# Statement of Environmental Effects

## Section 4.56 Modification

1 and 1A Balfour Street, Linfield

Modification of an approved mixed use development

Figure 3 – Approved MOD0219/21 East and South Elevations (Source: Rothelowman)

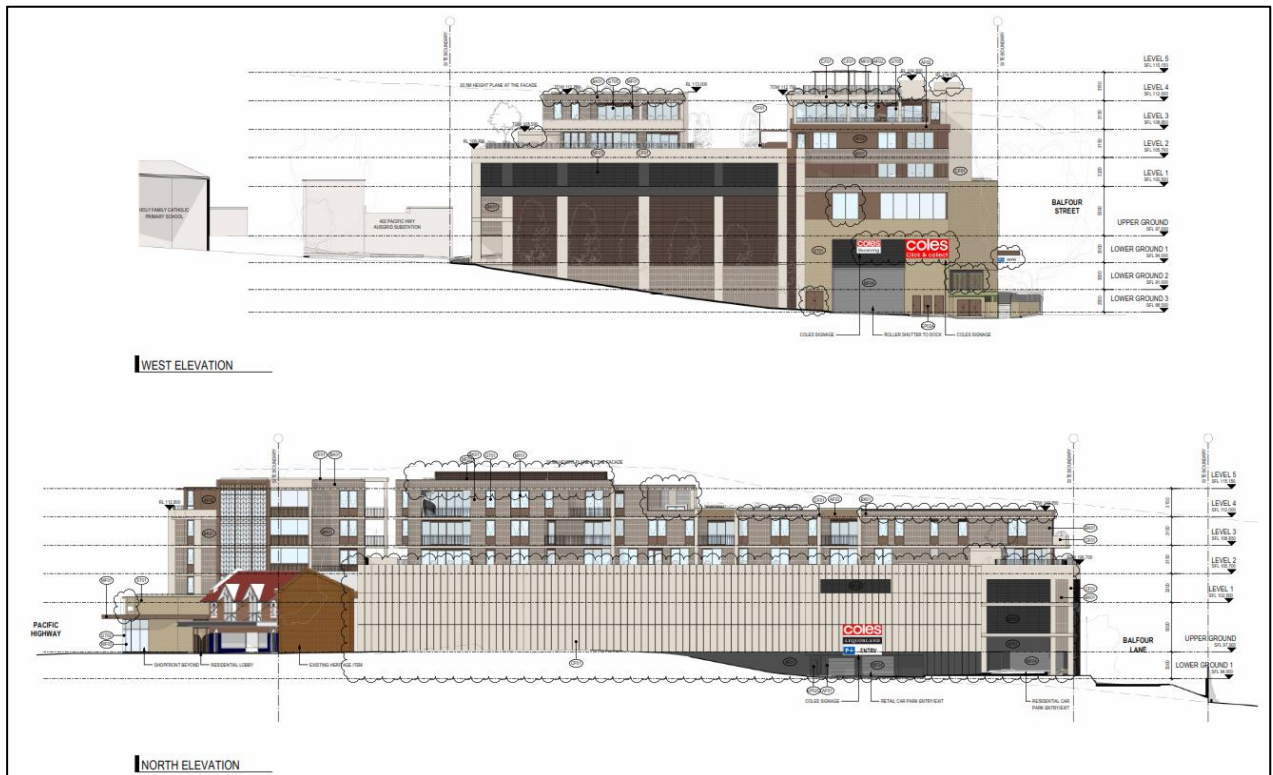
Level	Description of Modifications
Basement (DA01-1 Rev B)	<ul style="list-style-type: none"> <li>Increased rain water tank footprint</li> <li>Reduced and reconfigured fire tank footprint</li> <li>Relocated retail switch room to Lower Ground 2 – room repurposed for sewer and stormwater pit</li> </ul>
Lower Ground 2 (DA01-2 Rev D)	<ul style="list-style-type: none"> <li>Gas meter relocated</li> <li>Added sprinkler booster to Balfour Lane</li> <li>Relocated retail switch room from Basement level</li> </ul>
Lower Ground 1 (DA01-3 Rev D)	<ul style="list-style-type: none"> <li>Gas meter relocated</li> <li>Cold water pump room added (relocated from basement)</li> <li>Services room added behind Lifts 1 &amp; 2</li> <li>Extended blade wall beyond fire stair for shielding</li> </ul>
Upper Ground (DA01-4 Rev D)	<ul style="list-style-type: none"> <li>Window relocated to Coles back of house area</li> </ul>

Level 1 (DA01-5 Rev D)	<ul style="list-style-type: none"> <li>Adjusted waste room, fan room &amp; retail switch room - cars relocated to suit, no net loss</li> <li>Additional fan room &amp; storage cages relocated to suit, no net loss</li> </ul>
Level 3 (DA01-7 Rev D)	<ul style="list-style-type: none"> <li>Relocated solar panels to Level 4 roof</li> </ul>
Level 4 (DA01-8 Rev D)	<ul style="list-style-type: none"> <li>Increased external terrace area to PH07 and introduction of a spa</li> <li>Added Coles smoke exhaust and enclosure</li> <li>Added roof to Fire Stair 04</li> <li>General communal roof height increased to allow for waterproofing &amp; soil depths</li> <li>Parapet heights increased for fall protection and soil depths</li> <li>Additional glazing to Common Rooms to increase solar access and amenity</li> </ul>
Roof (DA01-9 Rev C)	<ul style="list-style-type: none"> <li>Increased extent of roof and parapet over PH07 external terrace</li> <li>Increased extent of 1800mm high plant louvre enclosure</li> <li>Reconfiguration of PH06 roof terrace, area maintained</li> <li>Low plant elements relocated to southern zone of northern roof</li> </ul>

<ul style="list-style-type: none"> <li>• Parapet to Pacific Highway frontage increased from RL115.350 to RL116.150</li> <li>• Increased plant zone perimeter to allow for Coles chiller equipment;</li> <li>• Added roof to Fire Stair 09</li> </ul>
Signage (DA01-10 Rev C)	<ul style="list-style-type: none"> <li>• Updated Coles &amp; Liquourland signage to all frontages</li> <li>• Under awning sign added to Balfour Street</li> <li>• Updated signage schedule</li> </ul>
Elevations (DA02-1 Rev C)	<ul style="list-style-type: none"> <li>• Updated Coles signage to Pacific Highway &amp; Balfour Street frontages</li> <li>• Updated roof plant louvre enclosure</li> <li>• Parapet heights increased for fall protection and soil depths</li> <li>• Updated window breakup and stepped sill for buildability and waterproofing</li> </ul>
Elevations (DA02-2 Rev C)	<ul style="list-style-type: none"> <li>• Window to Coles back of house area relocated</li> <li>• Under awning sign added to Balfour Street</li> <li>• Increased lift overrun height</li> <li>• Revised precast façade panel break up</li> <li>• Increased louvre area over residential entry ramp</li> <li>• Updated roof plant louvre enclosure</li> <li>• Parapet heights increased for fall protection and soil depths</li> <li>• Added sprinkler booster to Balfour Lane</li> </ul>

Figure 6 – Proposed Height Blanket (Source: Rothelowman)

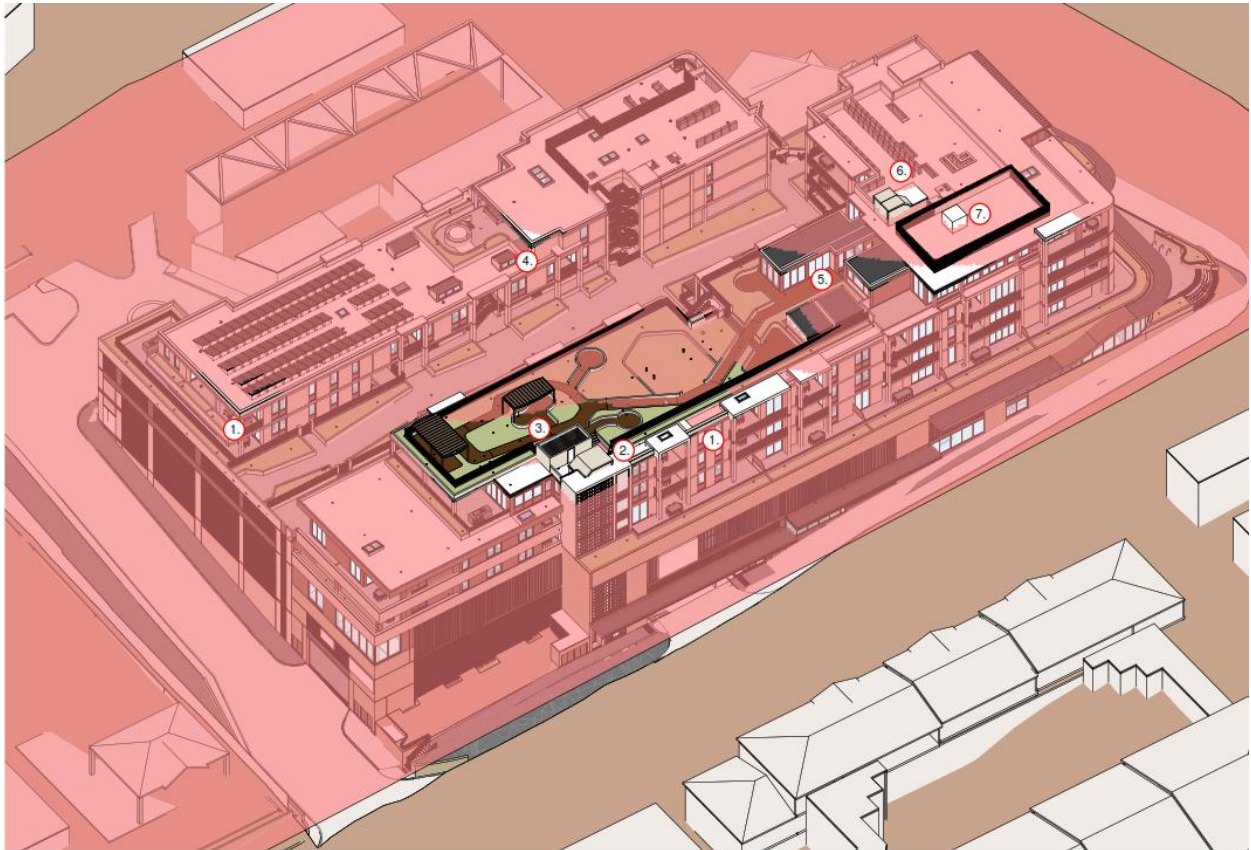
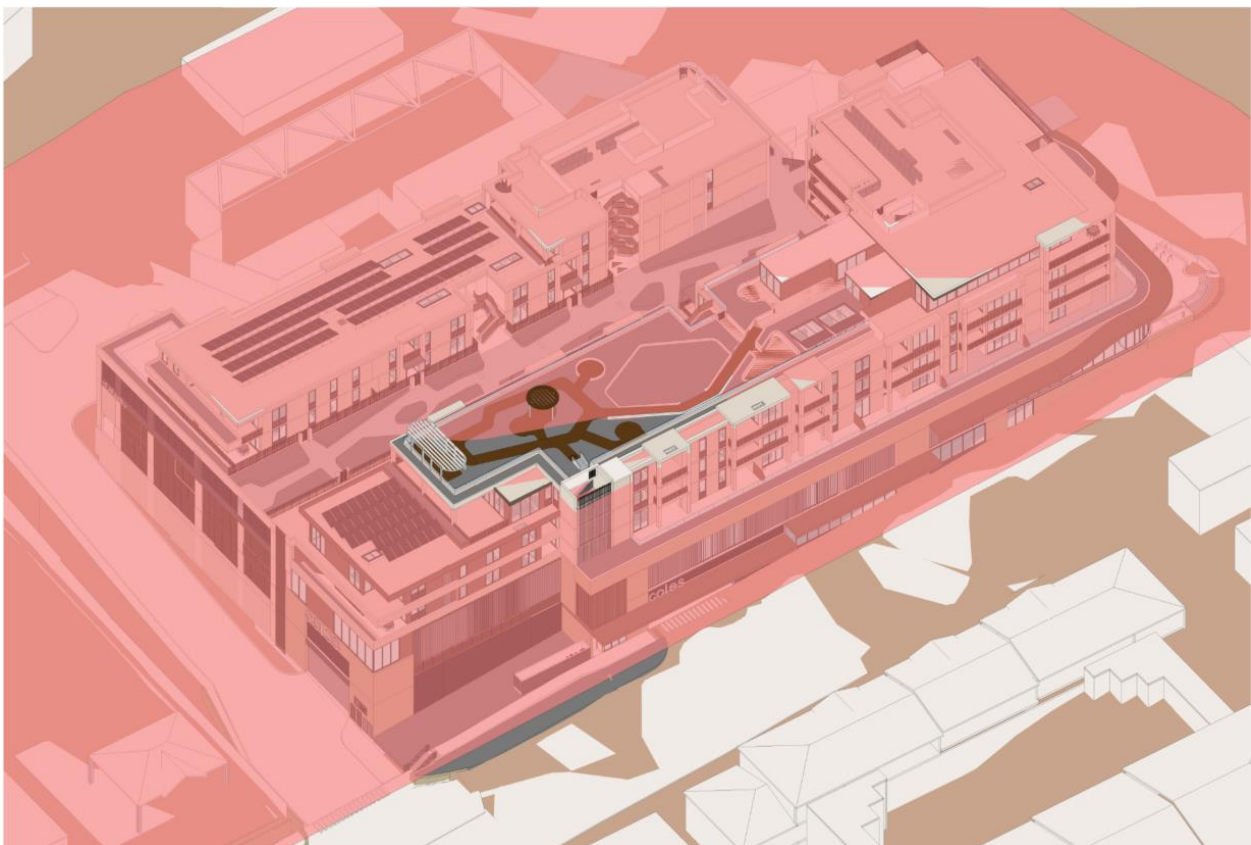
This Section 4.56 modification application seeks to vary the height of buildings development standard by a maximum of 2.35m or 11.46%. The proposed modification will result in a maximum building height of 22.85m. The development as approved provided a variation to the height of building development standard with a maximum building height of 23.16m or a 13% variation from the maximum permitted height of 20.5m.

Component	Proposed RL	Height Exceedance
1. Parapet Heights	112.75 RL	0.93m
2. Roof to Fire Stair 04	114.05 RL	2.25m
3. Smoke Exhaust Enclosure	114.3 RL	2.35m
4. Roof and Parapet over Ph07	115.55 RL	0.86m
5. Common Room Heights	115.45 RL	0.77m
6. Roof Stair 09	117.7 RL	1.47m
7. Plant Enclosure for Chiller Equipment	117.05 RL	1.98m

- The proposed exceedances of the maximum permitted building height include a plant enclosure for chiller equipment that will benefit the supermarket. While the structure exceeds the permitted building height it has been further setback from the buildings edge minimising the opportunity to discern the structure from the public domain or an adjoining property. In this way it recedes into the building envelope of the approved development.

- Stairwell overruns to fire stair 04 and 09 have been introduced to benefit the approved stairwells. This has been included to mitigate against the ingress of water and remove the need for an engineering solution. The overrun is substantially setback from the building edge and any impacts will be internalised.

Figure 8 - Shadow Diagram Approved & Proposed (Source: Rothelowman)

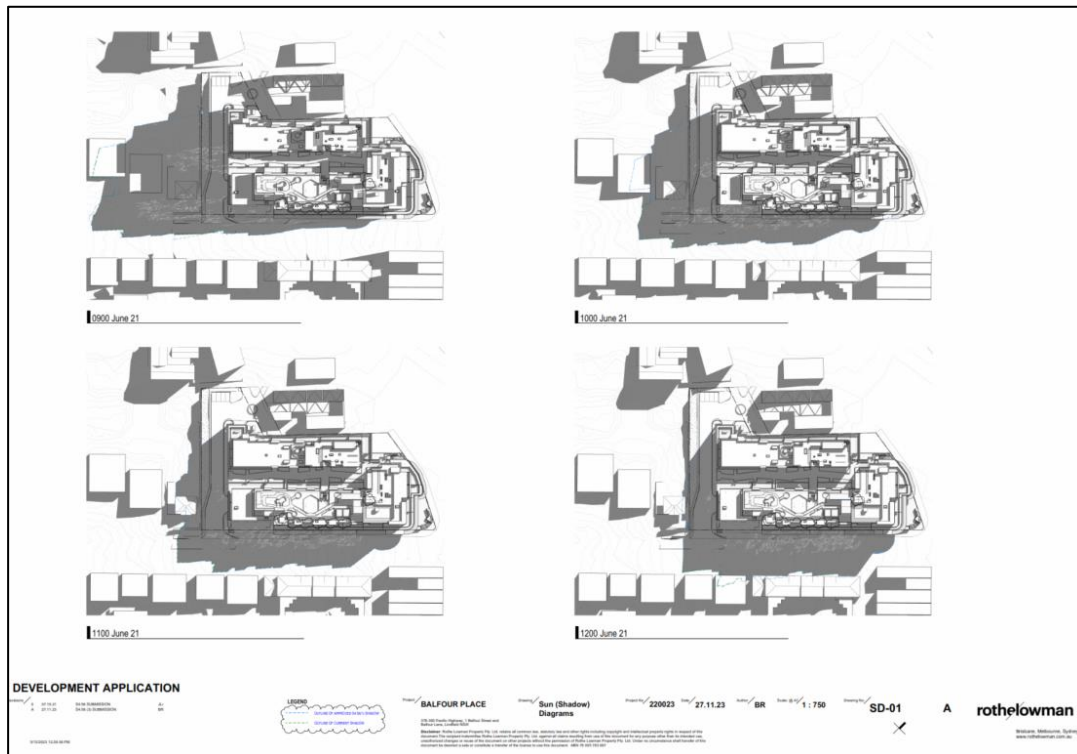
- In support of the application are shadow diagrams prepared by Rothelowman which considers the impact of overshadowing from the development as previously modified and as proposed to be modified – see **Figures 8 and 9**. This demonstrates that while the development will result in a minor increase in overshadowing from the previous modification it remains less overall than originally approved. Those residential uses to the south retain adequate solar access with Balfour Street acting as a buffer.
